SUBJECT: COMANCHE PEAK NUCLEAR POWER PLANT, UNITS 3 AND 4
DOCKET NUMBERS 52-034 AND 52-035
SUPPLEMENTAL RESPONSE TO REQUEST FOR ADDITIONAL INFORMATION
221 (5798) AND RESPONSE TO REQUEST FOR ADDITIONAL INFORMATION
247 (6266) (SECTION 3.7.2)

Comanche Peak, Units 3 and 4

RAI 221 (5798)

RAI 247 (6266)

Figure 1 - 5% Damping ISRS Comparison for UHSRS Cut-off Frequency Verification Study

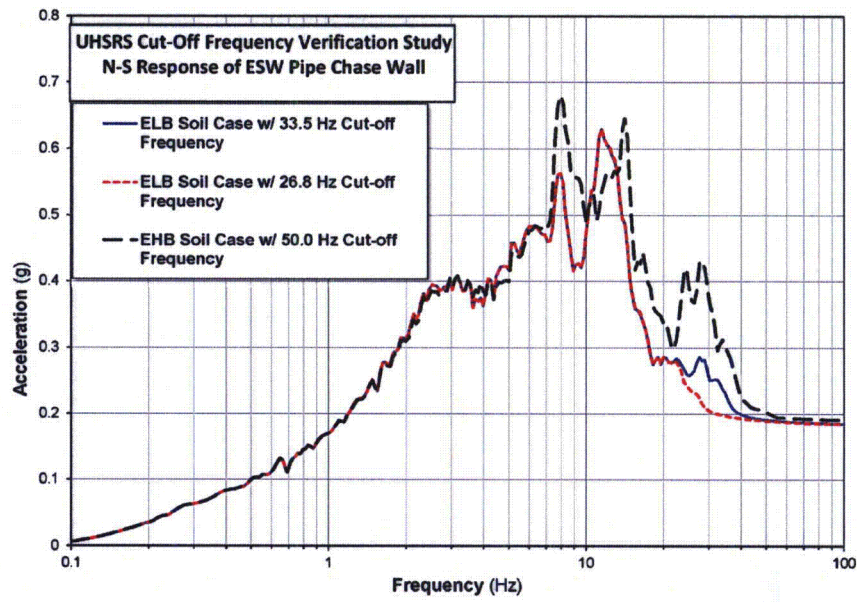
2. Items 5, 7, 10, and 13 of Question 3.7.2-23 asked the Applicant to provide justification that it is acceptable to use soil layers in the SSI evaluation that have maximum passing frequencies less than the cutoff frequency of the analysis. The response stated in Item 5 that although the backfill soils do not pass frequencies as high as the cutoff frequencies used, the analyses did not show abnormal behavior beyond the passing frequencies because the structural input does not rely on these soils to excite the structure and all time-history energy is at low frequencies. Similar responses were provided for Items 7, 10, and 13. The staff does not accept this logic for using passing frequencies that are less than the cutoff frequency. In general the time history energy will decrease with increasing frequency, and the lack of a global structural response at higher frequencies does not imply that higher frequencies can be neglected because they may be important for equipment response. The Applicant is requested use SSI models that have maximum passing frequencies that are greater than or equal to the minimum required cutoff frequency, or else provide studies to show that the not doing so results in accurate or conservative results.

The analyses of UHSRS and PSFSV embedded models for lower bound and best estimate soil profiles utilized values of the cut-off frequencies that are approximately 20 percent higher than the passing frequency of some of the layers in the backfill soil models. Similarly, in the SSI analyses of the ESWPT, the passing frequency of some of the layers in the lower bound profile is above 45 Hz, but below the cut-off frequency of 50 Hz. To verify the accuracy of the SASSI analyses results that used cut-off frequencies higher than the passing frequencies, verification studies were performed on UHSRS and PSFSV embedded models as described in FSAR Sections 3KK.2 and 3MM.2, respectively. The studies compared ISRS obtained from SASSI analyses with a cut-off frequency of $V_s/5d$ versus ISRS obtained from analyses with a cut-off frequency closer to $V_s/4d$. These studies also compared the lower bound or best estimate ISRS to the ISRS obtained from SASSI analyses of upper or high bound profiles, which govern the design basis ISRS at higher frequencies. The results of these verification studies demonstrated that the SASSI analyses, performed with cut-off frequencies 20 percent higher than one-fifth wave length passing frequency, produced results that do not impair the accuracy of design basis ISRS. Figures 1 and 2 provide typical examples of the verification studies results.

Figure 1 - Node Group Used for Generation of ISRS for ESWPT Segment 1aN Exterior Walls

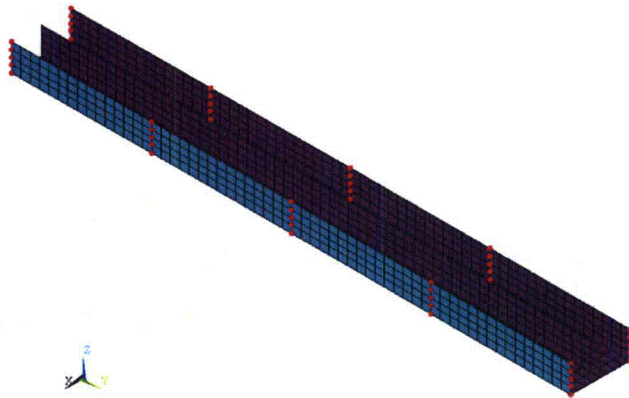
2. In Item 6 of the response to Question 3.7.2-24, the Applicant provided the requested node numbers from the applicable finite element models, but the staff is unable to complete the review of this response because many of the Figures in Appendices 3KK through 3MM showing the in-structure response spectra (ISRS) do not indicate the node numbers for which the ISRS were generated. The staff requests that the Applicant provide the specific node numbers for all ISRS presented in Appendices 3KK through 3MM.

- Groups of nodes are used to generate the ISRS shown in Appendices 3KK through 3MM for the different structure components. The groups of nodes are selected to represent the key locations, including edges and centers, of the structure's components (i.e., walls, slabs, roof, and basemat). The number of nodes and locations are selected to provide design-basis ISRS that envelope the responses at different locations within the component. Examples of node groups used in the generation of ISRS are presented below in Table 1, Figure 1, Figure 2, and Figure 3, for the ESWPT, PSFSV, and UHSRS, respectively. A complete list of node numbers used for generation of ISRS is not presented herein. The calculations containing the complete list of nodes and the breakdowns of node groups used in generation of ISRS are available for NRC audit.
